WRB7 - Replacing Weather Sensor (Workshop Campaign)

Model Line: **Cayenne (9YA / 9YB)**

Concerns: **Weather sensor**

*Installation position of weather sensor*

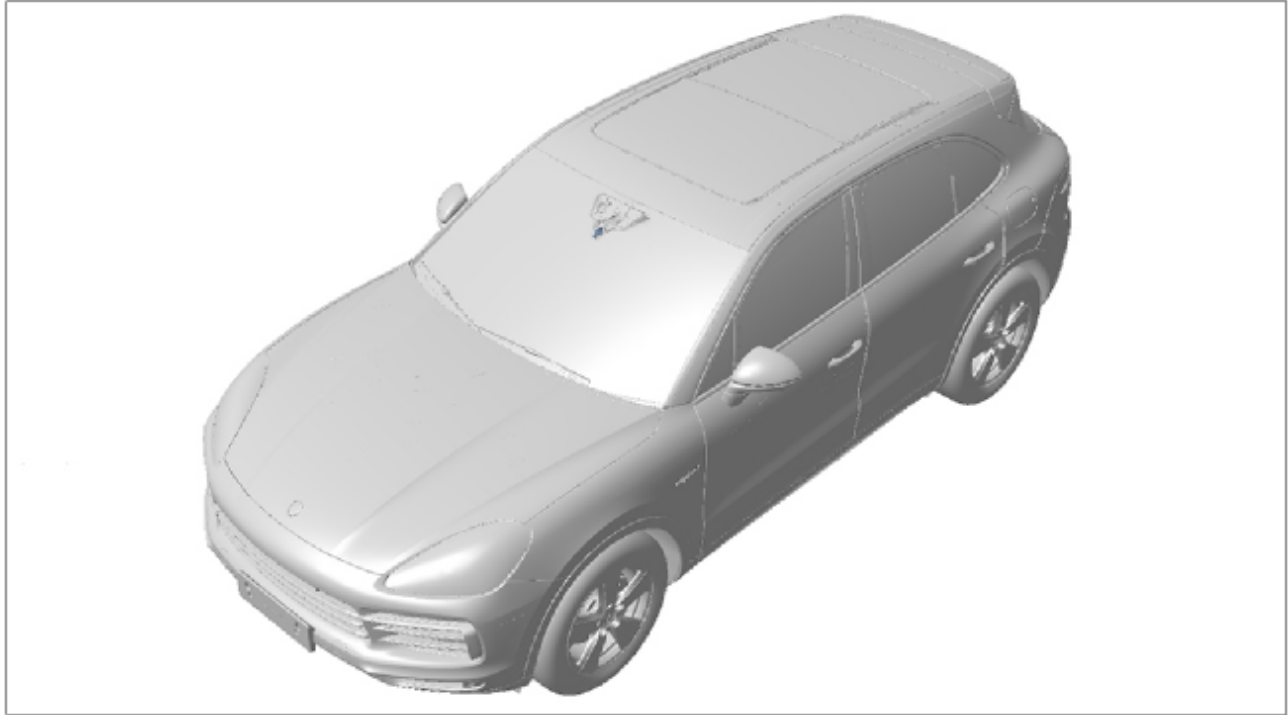
Cause: **A weather sensor which does not meet the required specifications was installed on the affected vehicles.**

This can lead to faulty behavior of the Night View Assist.

Action: Replacing the weather sensor.

- Work Procedure: 1 Replacing the weather sensor. ⇒ *Workshop Manual '921255 Replacing weather sensor'*
- 2 Enter the campaign in the Warranty and Maintenance logbook.
